Georgetown Charter Township

Planning Commission Meeting Agenda

BALDWIN WOODS

RE: Baldwin Woods – Revised Preliminary PUD & Final Development Plan

SHEET NO: C-102

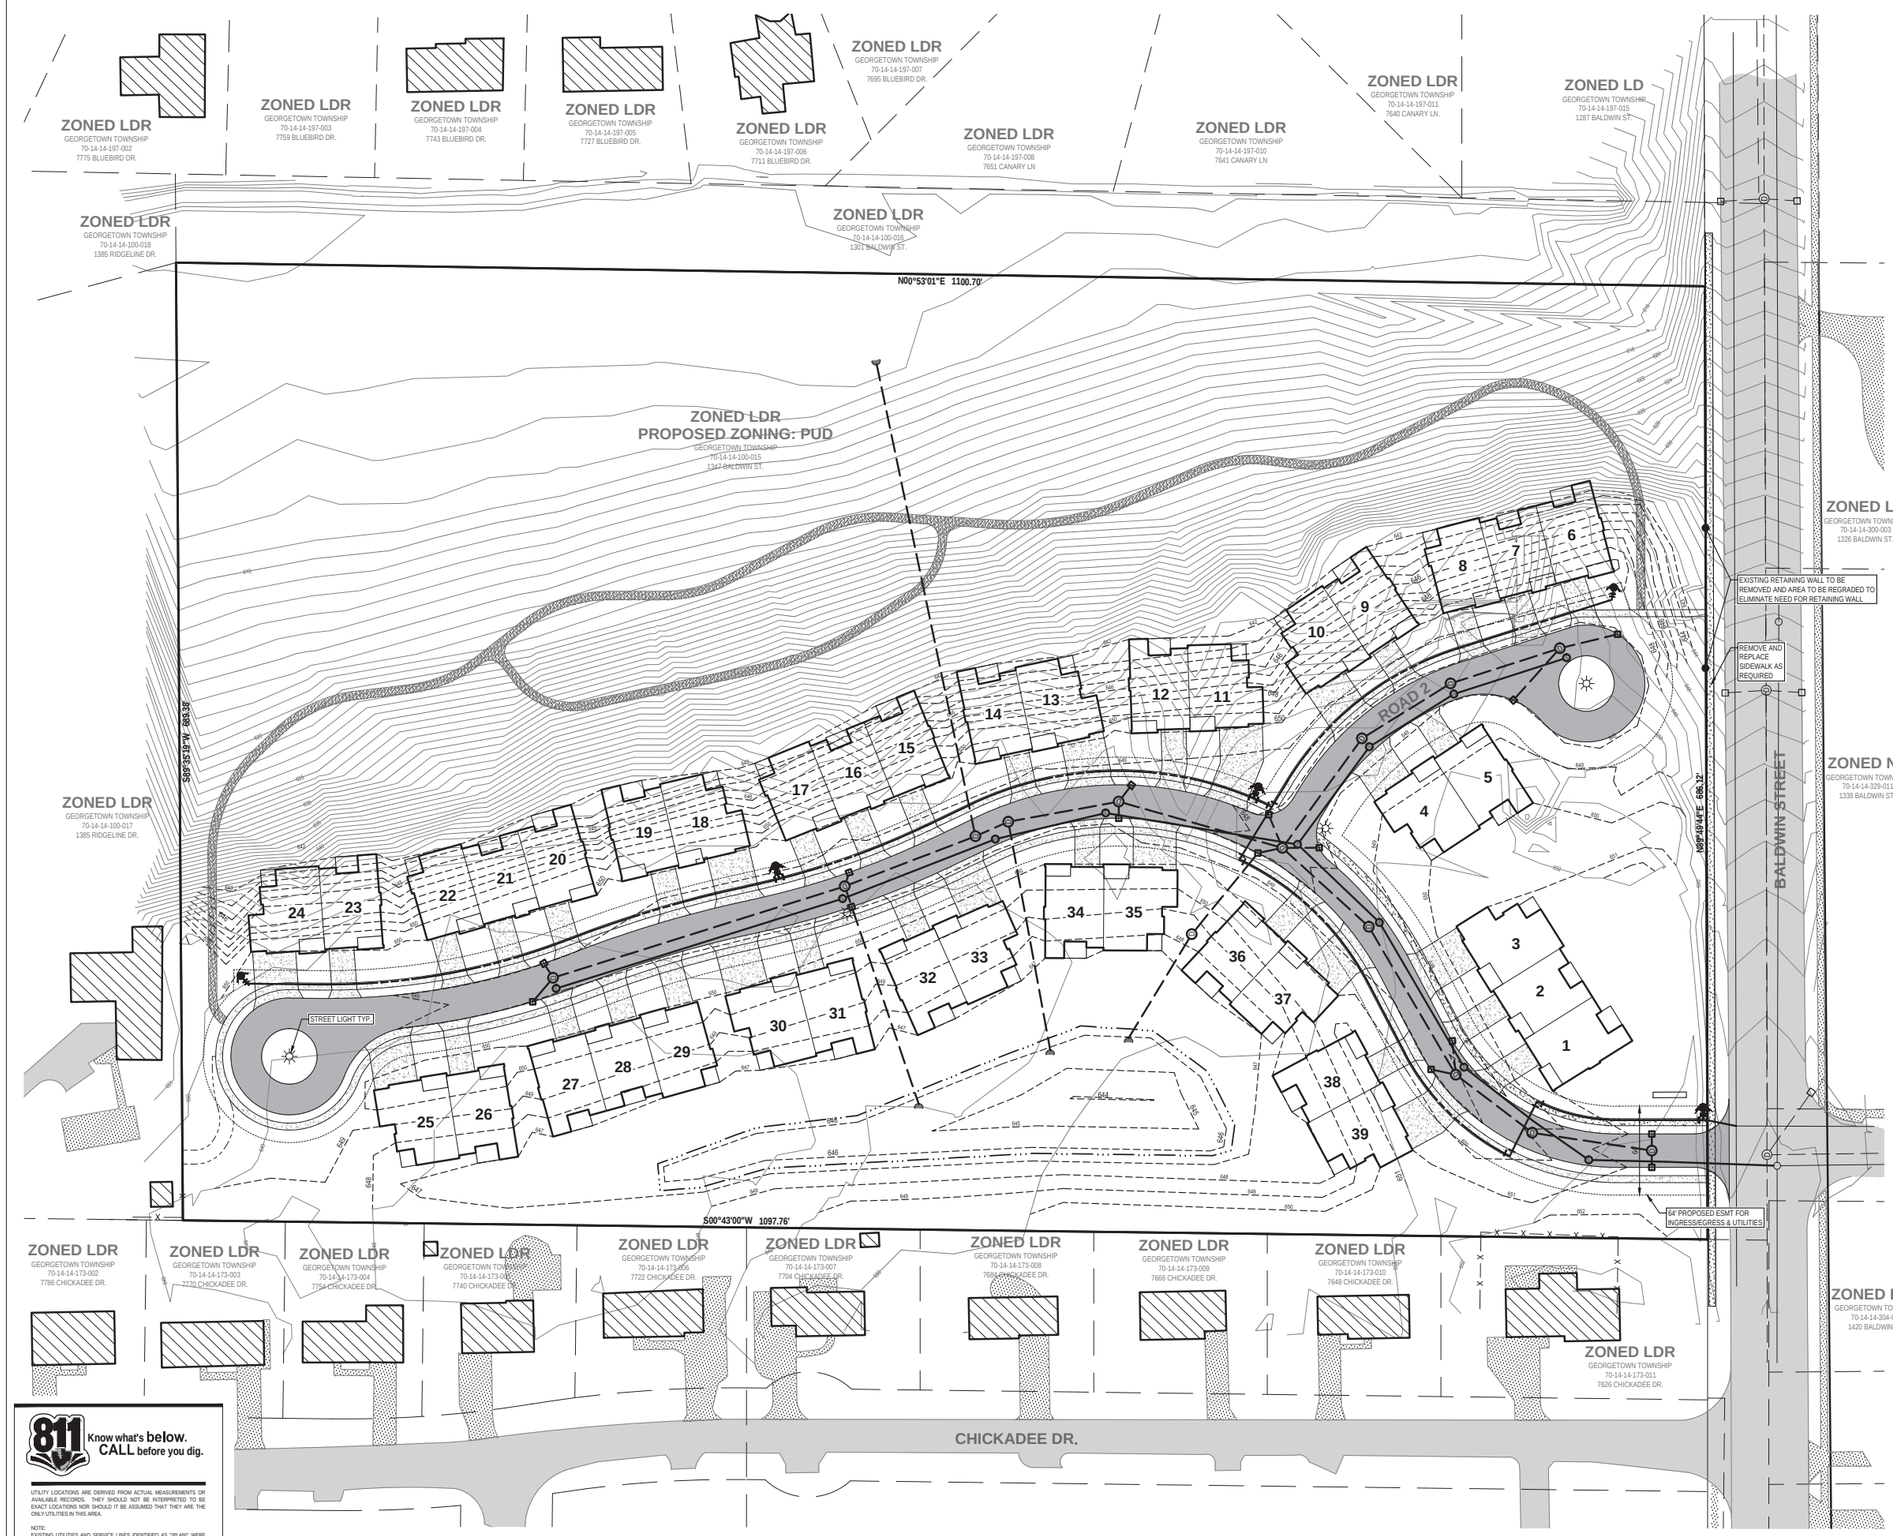
Comment: Interior sidewalks and pedestrian paths are proposed, along with sidewalk adjacent to Baldwin St. Indicate either on the plan or on a separate document that the hill to the sidewalk along Baldwin will be graded and the retaining wall removed.

Response: **See C-102, retaining wall to be removed and area to be regraded to eliminate the need for a retaining wall.**
